LRD Planning Application

LRD6018/22-S3

Further Information Response

**Carlisle Residential
Development, Kimmage Road
West, Kimmage, Dublin 12**

Figure 3.2 Green Roof Extensive

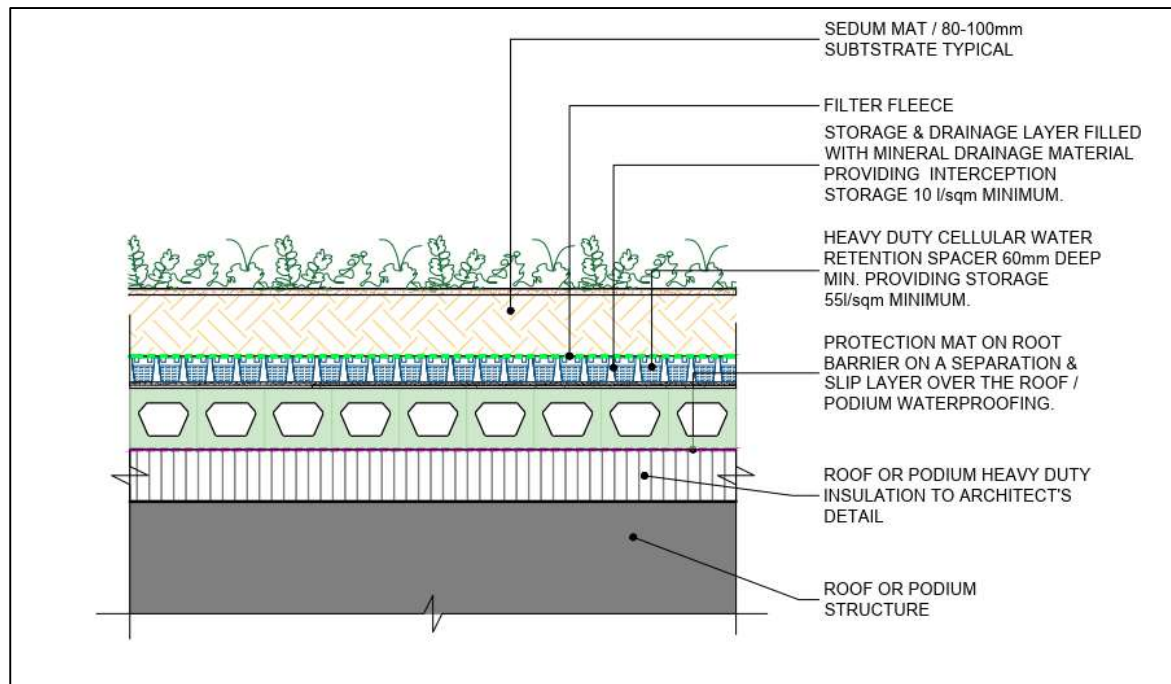
‘.....The use of underground attenuation tanks is not in accordance with the design approach and hierarchy outlined in DCC policies. Attenuation tanks shall only be considered when all other SuDS systems have been utilised in the first instance and where alternative storage mechanisms are deemed unfeasible. Applicant is required to demonstrate this in the design. It is not clear why green areas are not being utilised as multi-functioning areas to support sustainable drainage design. The Planning Report and drawings suggest a blue roof has been incorporated into the design, but this is not substantiated by the Infrastructure Report.....’

Refer to Fig 3.2 for cross section through extensive green blue roof. Extensive roofs have low substrate depths and therefore low loadings on the building structure, they are lightweight and have a low cost to maintain. These systems cover the entire roof area with hardy, slow growing, drought resistance, low maintenance plants and vegetation, such as sedums. The planting usually matures slowly, with the long-term biodiverse benefits being the sought-after results. These roofs are typically only accessed for maintenance and are usually comprised of between 20mm – 150mm overall total depth.

Extensive green roofs have the effect of providing some initial storage of rainwater, while also reducing the rate at which rainwater from heavier rainfall events will discharge to the main attenuation tank. It can also help to filter the run-off, removing any pollutants and resulting in a higher quality of water discharging to the drainage system. A typical extensive green roof system can intercept and retain over 30 litres/m² (i.e. 30 mm) depending on the build-up. Since these roofs are exposed to the Irish climate, there is a high probability that the roof will not be completely dry, and the storage capacity will be compromised on any given rainfall event. Thus, the more conservative estimate of 10 litres/m² (12mm) interception storage has been assumed. The addition of the blue roof will provide attenuation storage of 55 l/m². This will reduce the attenuation tank size required downstream and which is best practice in accordance with DCC policy SI23.

Figure 3.5 Permeable Paving Build-up

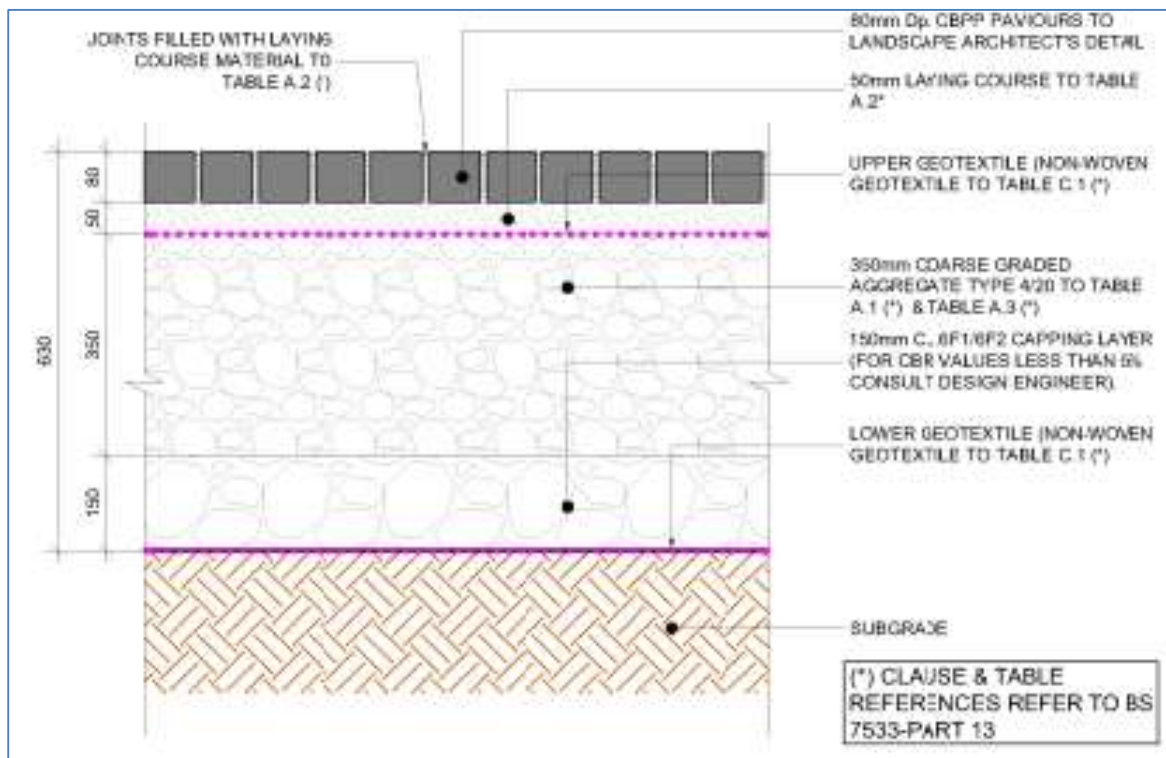
'....The Infrastructure Report submitted with the application suggests that the required interception volumes are met however interception should be delivered at source and overprovision of interception in some areas to compensate for under provision / no provision in others should be avoided. Extent of individual surface areas and corresponding volumes should be provided....'

Refer to Fig 3.5 for cross section through permeable paving. Permeable paving provides a surface suitable for pedestrian and/or vehicular traffic, while also allowing rainwater to infiltrate through the surface and into the underlying structural layers. The water is temporarily stored beneath the overlying surface before slowly infiltrating. Permeable paving systems are an effective way of managing surface water runoff close to its source. The car parking spaces outside of the building footprint of the site will be made up of permeable paving.

By providing a raised drainage outlet above the base of the coarse graded gravel bed it is possible to achieve interception storage. Raising the invert of the drainage pipe to 100mm above the gravel bed gives 40mm interception storage @ 40% voids in the gravel.

Fig 3.7 Eastern CFRAM Study – Poddle River Fluvial Extents

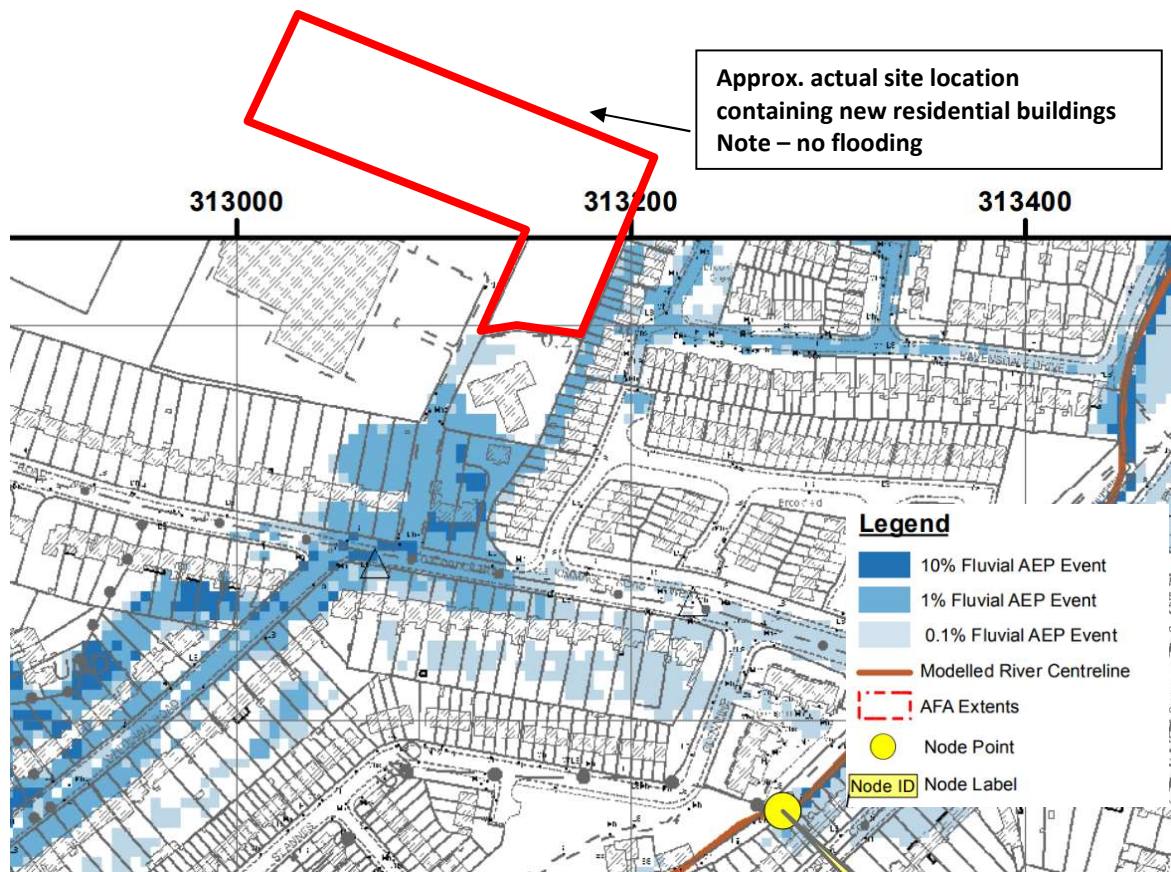
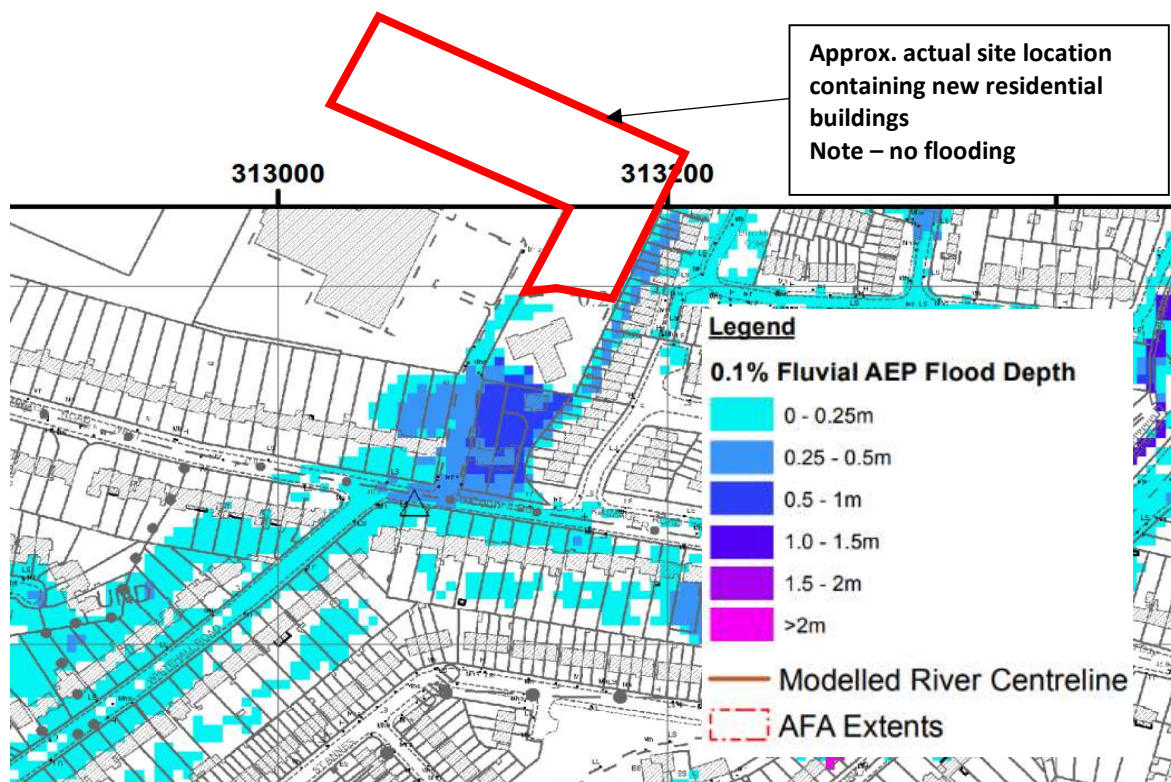
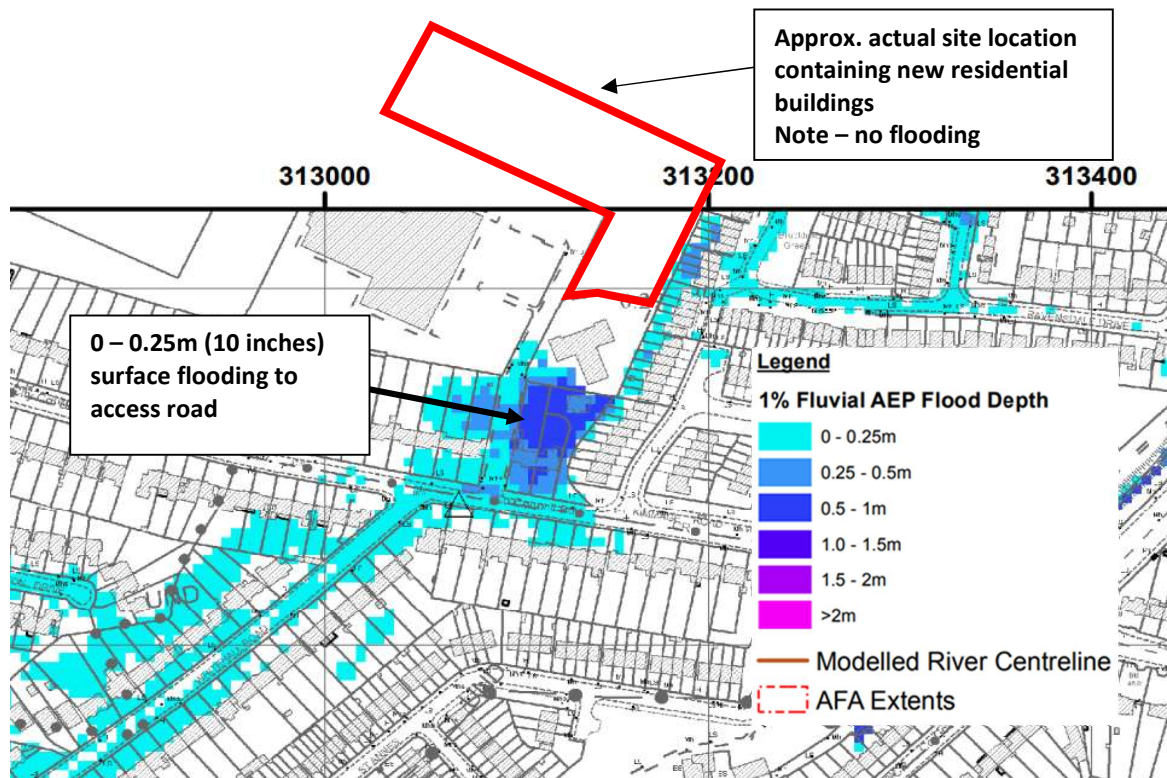
'.....It is not obvious from the Site Specific Flood Risk Assessment that the effect of the proposed development on neighbouring/adjacent sites and beyond the site boundary has been considered....'

In the following pages, we have included extracts of the relevant flood maps for the area, from the Eastern CFRAM Flood Study, which are available online at OPW website 'floodinfo.ie

The above flood map extracts indicate some minor surface flooding of the existing access road, which serves the existing Gym premises. It is not proposed to change the levels of this existing access road and therefore there is no increased flooding risk to the access road or surrounding properties. Certain resurfacing works and line marking are proposed to the existing access road, and certain underground services are proposed to be installed under the existing road.

The estimated maximum depth of surface flooding in the 1 in 100 year event is estimated in region 0 – 0.25m (0 – 10 inches)

The estimated maximum depth of surface flooding in the 1 in 1000 year event is estimated in region 0 – 0.50m

In the highly unlikely scenario of a fire or medical emergency occurring in the subject development, at the same time as a 1 in 100 year flood event or a 1 in 1000 year flood, a fire tender and / or ambulance vehicle could still traverse the access road. There is no risk posed to emergency access by the predicated surface flooding of the existing access road.

Furthermore, the proposed new internal roads associated with the new development are all confined to the area immediately around the new buildings and are all in an area which is demonstrably within Flood Zone C.
